DESIGN #	DRAWN BY #	DART AEROSPACE LTD HAWKESBURY, ONTARIO, CANADA	
CHECKED CP	APPROVED #	DRAWING NO. DSI 9192	REV. A SHEET 1 OF 2
DATE 00.10.24	TITLE ADD D350-607-043/-044		SCALE NTS
A	00.10.24	NEW ISSUE

DART SERVICE INSTRUCTION

TO AMEND INSTALLATION DRAWING D350-607 REV. E
REF. CANADIAN STC SH94-14 & FAA STC SR00213NY

D350-607-043 HELI-UTILITY-BASKET

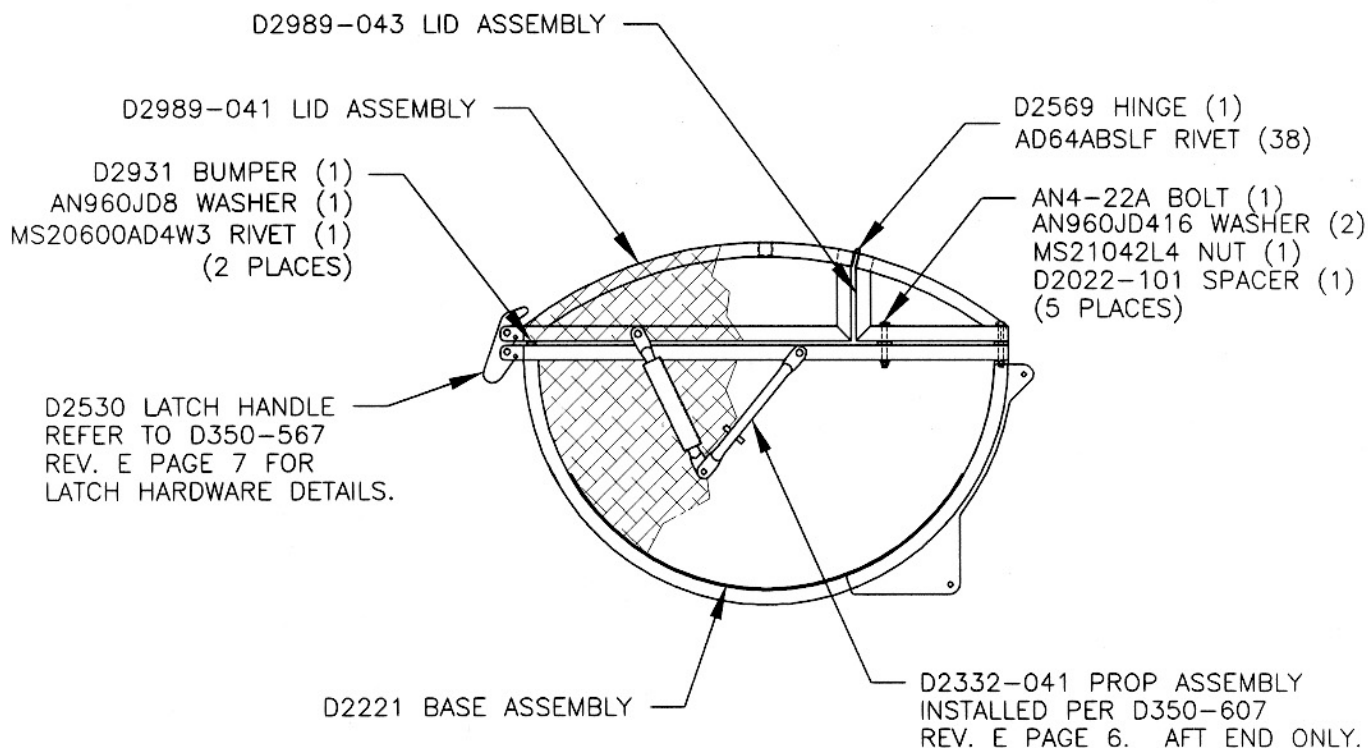
FOR COMPATABILITY WITH EUROCOPTER CANADA "SQUIRREL CHEEKS", INSTALL D350-607-043 INSTEAD OF D350-607-041. D350-607-043 CAN BE CONVERTED INTO A D350-607-044 BY MOVING THE D2332-041 PROP ARM ASSEMBLY TO THE AFT END OF THE BASKET AND SWITCHING THE FWD AND AFT MOUNTING BRACKETS.

(SECTION C-C OF D350-607 REV E)
INSTALL PER PAGES 3-5 OF D350-607 REV. E
